Fuel Hose Routing and Inspection

2001 Model Year 135/150/175 HP Optimax

S/N OT178500 Thru OT364902

58807

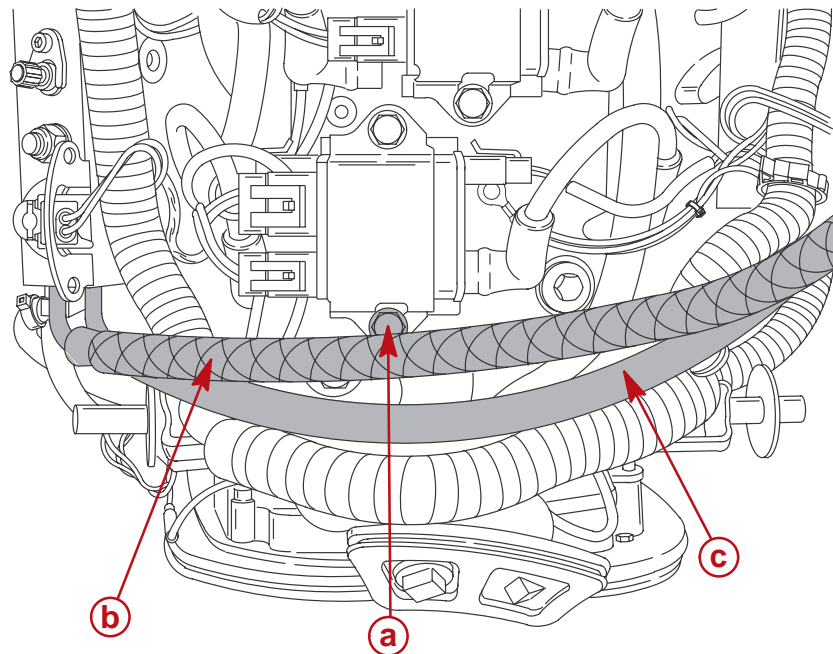
The fuel balance hose between the port and starboard fuel rail could come in contact with an ignition coil driver mounting bolt. This could cause the hose to wear/chafe, at the point of contact with the bolt. If allowed to continue, this could cause a fuel leak.

- a** - Coil driver mounting bolt (may contact fuel hose)
- b** - Fuel balance hose
- c** - Air balance hose

Port Bottom Fuel Rail Connections

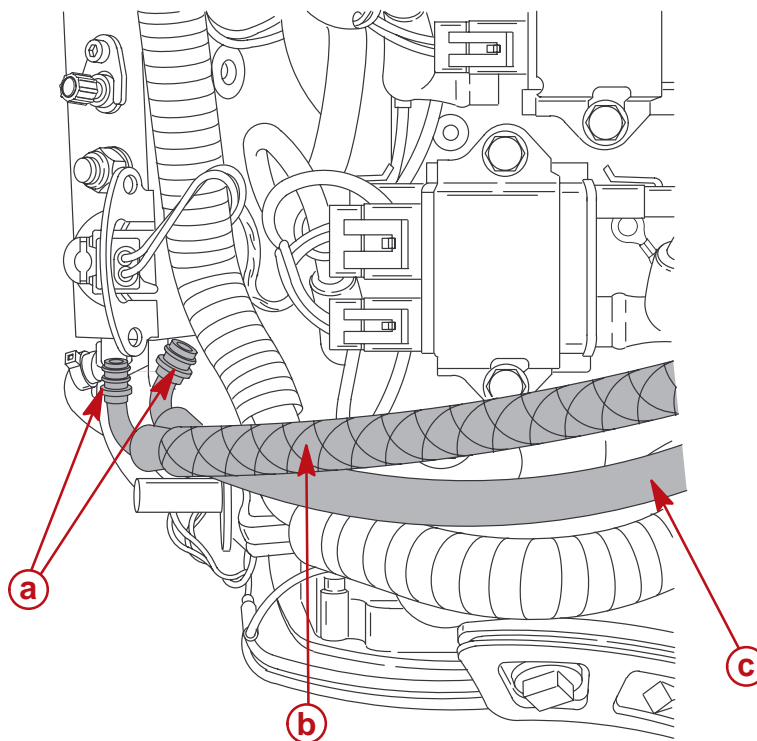
- Remove the top and bottom cowls.
- Remove the two allen head bolts, and hose retainer plate from the bottom of the port fuel rail.

- a** - Water inlet hose to fuel rail
- b** - Air balance hose
- c** - Allen screws (remove)
- d** - Fuel balance hose

58808

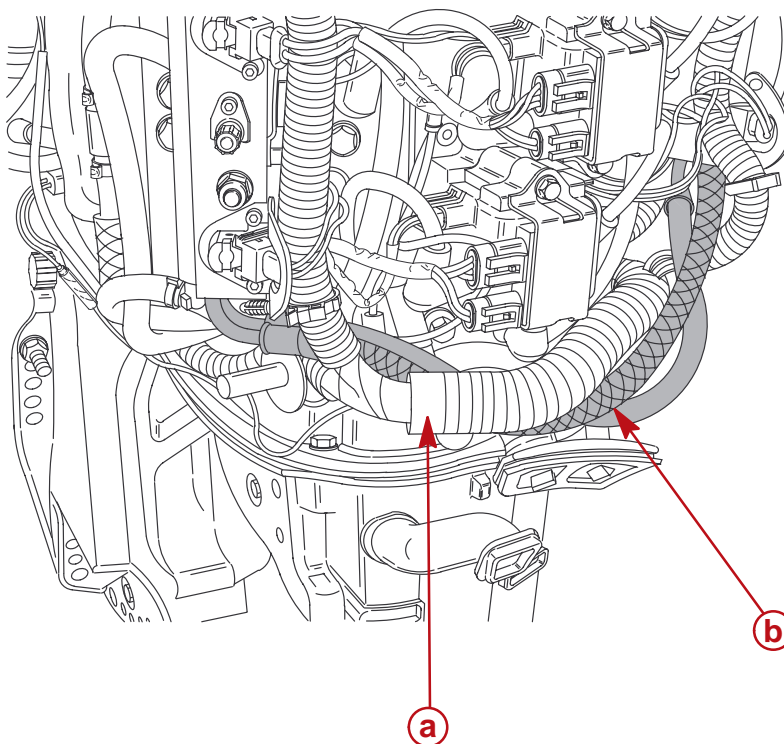
- Pull both the fuel and air balance hoses out of the rail.

- a** - Connector O-rings, coat with 4-stroke oil before assembling
- b** - Fuel balance hose
- c** - Air balance hose
